# UNITED STATES PATENT AND TRADEMARK OFFICE

APPLICATION NO.	FILING DATE	FIRST NAMED INVENTOR	ATTORNEY-DOCKET NO.	CONFIRMATION NO.
10/748,542	12/30/2003	Rickey L. Fandel	70920-002	8565
29493	7590	01/09/2008	EXAMINER	
HUSCH & EPPENBERGER, LLC 190 CARONDELET PLAZA SUITE 600 ST. LOUIS, MO 63105-3441			GILBERT, WILLIAM V	
		ART UNIT	PAPER NUMBER	
		3635		
		MAIL DATE	DELIVERY MODE	
		01/09/2008	PAPER

<b>Office Action Summary</b>	<b>Application No.</b>	<b>Applicant(s)</b>
	10/748,542	FANDEL, RICKEY L.
	<b>Examiner</b>	<b>Art Unit</b>
	William V. Gilbert	3635

**DETAILED ACTION**

***Figure 2 from Weckerly***

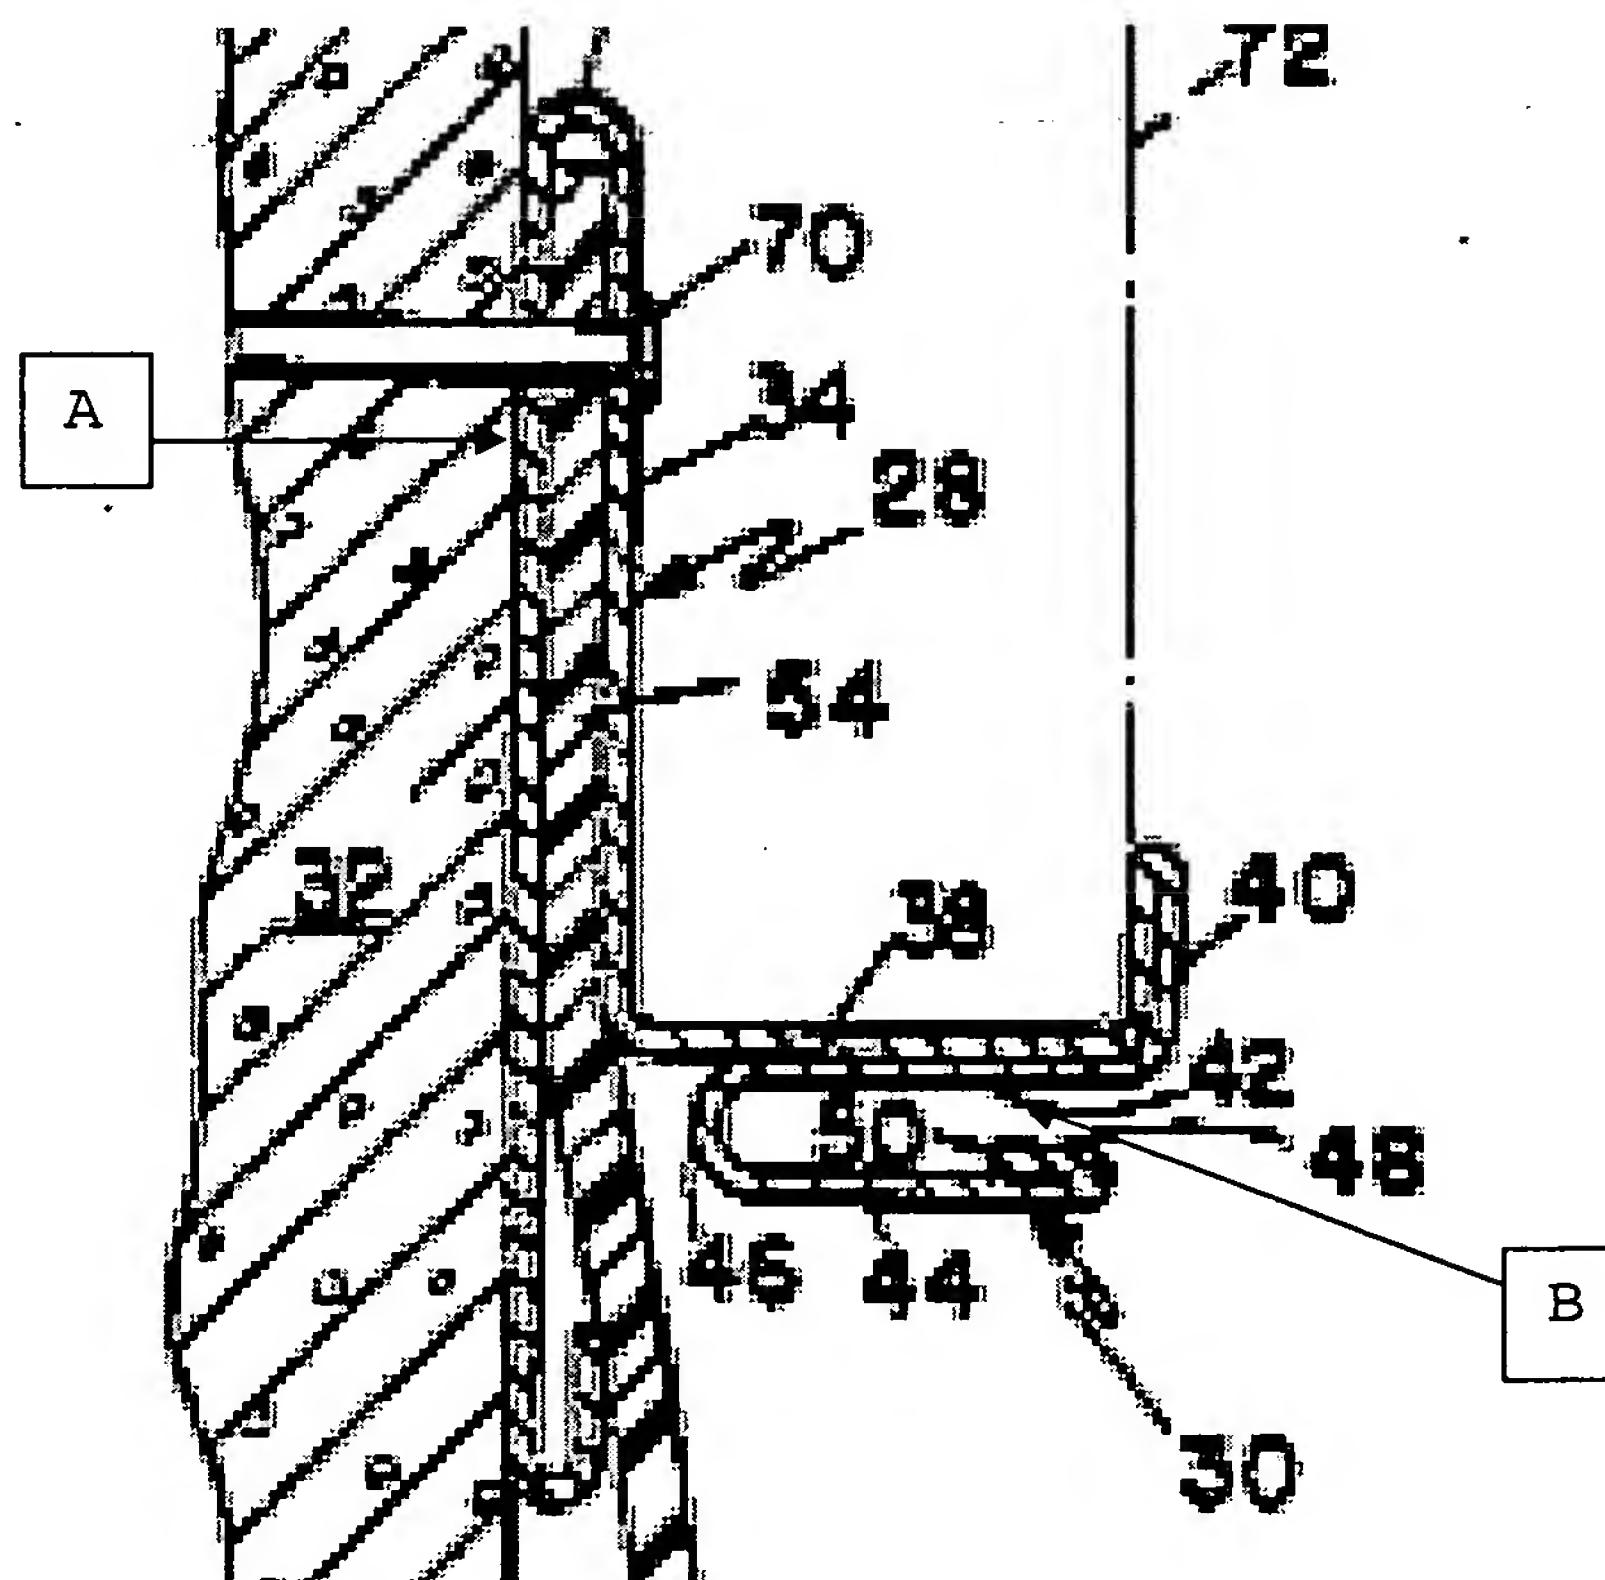
Claim 1: Weckerly discloses a flashing receiver (20) comprising a thin gage material having first and second legs (see "A" and "B" respectively from Figure 2, below from Weckerly), the first leg is not parallel to the second leg (see portion 42), the first leg has a height and extends longitudinally, the second leg has first and second sides, the first side is associated with a wall covering (72; portion proximate 40 is associated with the covering), and the second side is associated with a removable flashing (52; see Fig. 3), an intermediate member (34) offsetting the first and second legs, and a J-shaped channel (40, 42, 46 , 44, 48) that has a bottom (44) and outer extension (40) that is parallel to an entirety of the height of the first leg and the first leg extends at least as far as said bottom of the J-shaped channel.

Claim 13: Weckerly discloses a flashing receiver (20) comprising a thin gage material having first and second legs ("A" is the first leg and 34, 38 and "B" form the second leg, above), the first and second legs are not parallel (portion 42 is not parallel), the first leg has a top and bottom and extends longitudinally, a portion of the second leg forms a J-shaped channel (40, 42, 46, 44), the second leg has a first side associated with a wall covering (72) and a second side associated with a removable flashing (52), a plurality of nail slots (formed by 70) extending through the first and second legs and proximate the top, and an intermediate member (36) offsetting the first leg from the second leg, the intermediate

Claim 26: Weckerly discloses a flashing receiver comprising a thin gauge material having a first and second leg ("A" and "B" respectively), the two legs are not parallel, the first leg having a first extend in a first direction and a longitudinal extent forming a mounting face, the second leg has first (proximate 40) and second (42) sides, the first side is associated with a wall covering (72) and the second side is associated with a removable flashing (52), an intermediate member (36) offsetting the first leg from the second leg, a J-shaped channel (40, 42, 46, 44) in the second leg having a bottom (44) and outer extension (40) that is parallel to an entirety of the extent of the first leg in the first direction, the extent of the parallel portion is the first leg extends at least as far as said bottom of the J-shaped channel.
